**Southern Nuclear Operating Company
Vogtle Electric Generating Plant Units 3 and 4
Request for License Amendment:
Tornado Missile Protection for Main Steam Vent Stacks and Wall 11 (LAR-19-014)**

The requested amendment proposes changes to the evaluation of the auxiliary building main steam safety valve (MSSV) vent stack openings and the auxiliary building Wall 11 openings for protection from tornado-generated missiles.

**Tornado Missile Protection for Main Steam Vent Stacks and Wall 11
(LAR-19-014)**

Figure 1-2: AP1000 Plant Building Arrangement

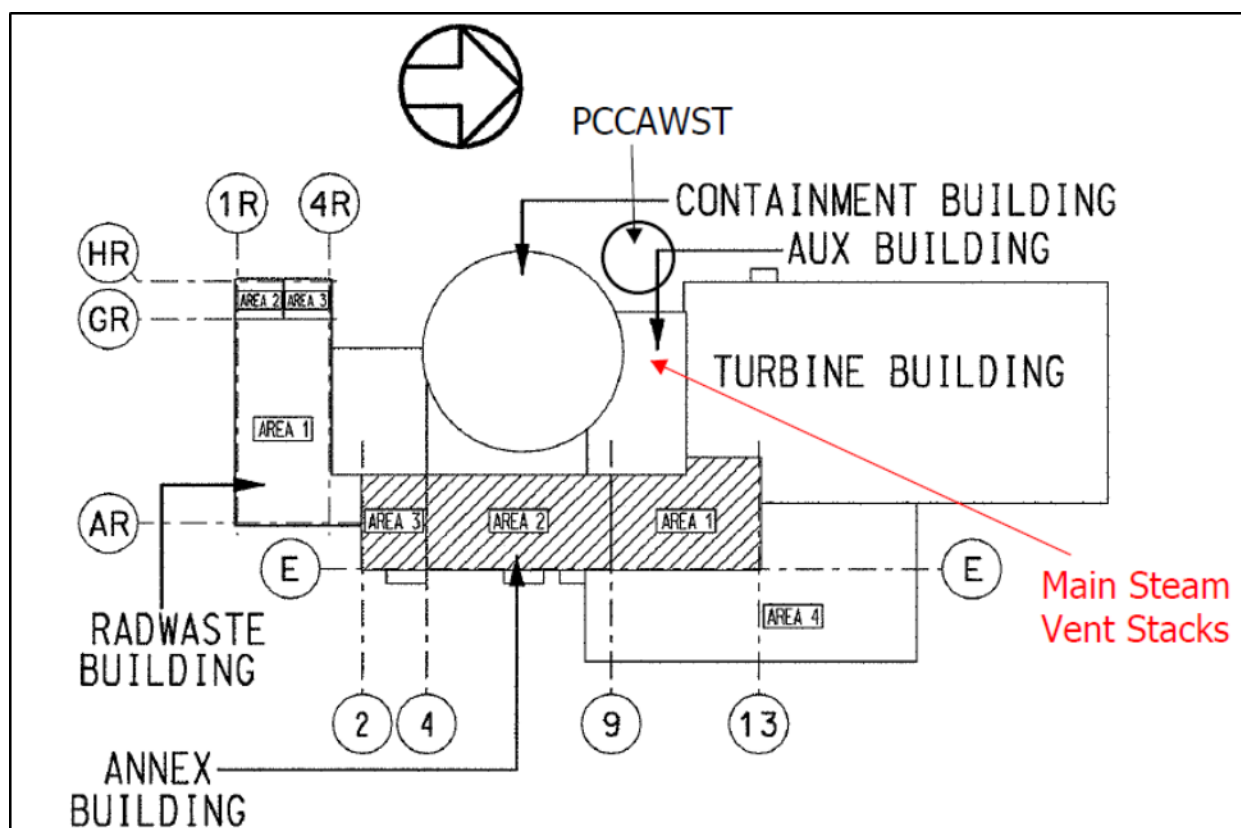
Based on the Vogtle site-specific topography and site layout, there is a limited line of sight to the main steam vent stacks. As shown in Figure 1-2 below, the annex building, containment building (shield building), turbine building first bay, and Passive Containment Cooling Ancillary Water Storage Tank (PCCAWST) surround the auxiliary building roof where the main steam vent stacks are located. As shown in Table 1-1 below, the surrounding structures exceed the elevation of the auxiliary building roof low point and will provide protection to the main steam vent stacks. The annex building (Column 2 to 9), shield building, turbine building first bay, and PCCAWST are above the elevation required to be evaluated for automobile missiles and will prevent an automobile from hitting the main steam vent stacks. The annex building (Column 9 to 13) elevation is below the max elevation evaluated for automobile missiles by 18". Due to the size of large debris (16.4' x 6.6' x 4.2'), part of the debris would hit the annex building (Column 9 to 13) wall and cause a ricochet. Therefore, there is no line of sight for automobile missiles if these buildings are in the missile path.

The shield building is seismic Category I. The turbine building first bay, annex building (portion credited), and PCCAWST are seismic Category II as shown in UFSAR Table 3.2-2 and Table 3.2-3. As described in UFSAR Subsection 3.3.2 and 3.5.2, seismic Category I and seismic Category II structures are designed to withstand the design basis tornado loads, including missiles. Therefore, the structures will stop the automobile missile from reaching the main steam vent stacks. See Figure 1-2 for the locations of these structures.

Based on the elevation of the vent stacks, Vogtle site topography, and arrangement of surrounding building, an automobile missile is not a credible impact on the vent stacks.
